Seattle Design Commission

MINUTES OF THE MEETING 18 September 2003

City Monorail Implementation Team High Point Master Plan Center City Circulation Study Fremont Bridge Approach Sustainable Design Checklist Design Commission 35th Anniversary Project

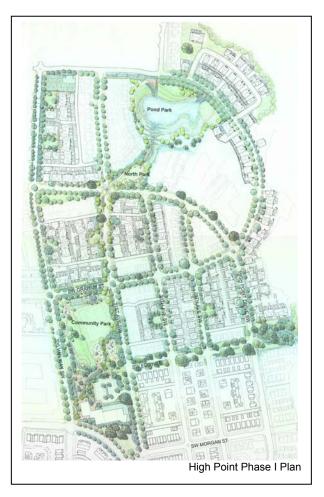
- Wonders what the darker buildings on the map indicate as opposed to the lighter buildings.
 - Proponents explained that the darker buildings are SHA affordable housing, tax credit housing, and public housing. The lighter buildings are market rate housing.

- Is concerned that there are not active spaces for older kids, such as basketball courts and hard surfaces. Notes that this is a key group that SHA needs to work actively to engage in the community.

- Wonders how the pocket parks are each unique.
 - Proponents explained that the pocket parks are not all the same shape. They also noted that some pocket parks have existing trees while others don't. They added that the planting patterns are different for each of the parks.

- Feels that the alleys should be incorporated into the open space plan for the area. Notes that they will be the natural gathering place for the older kids and teenagers.
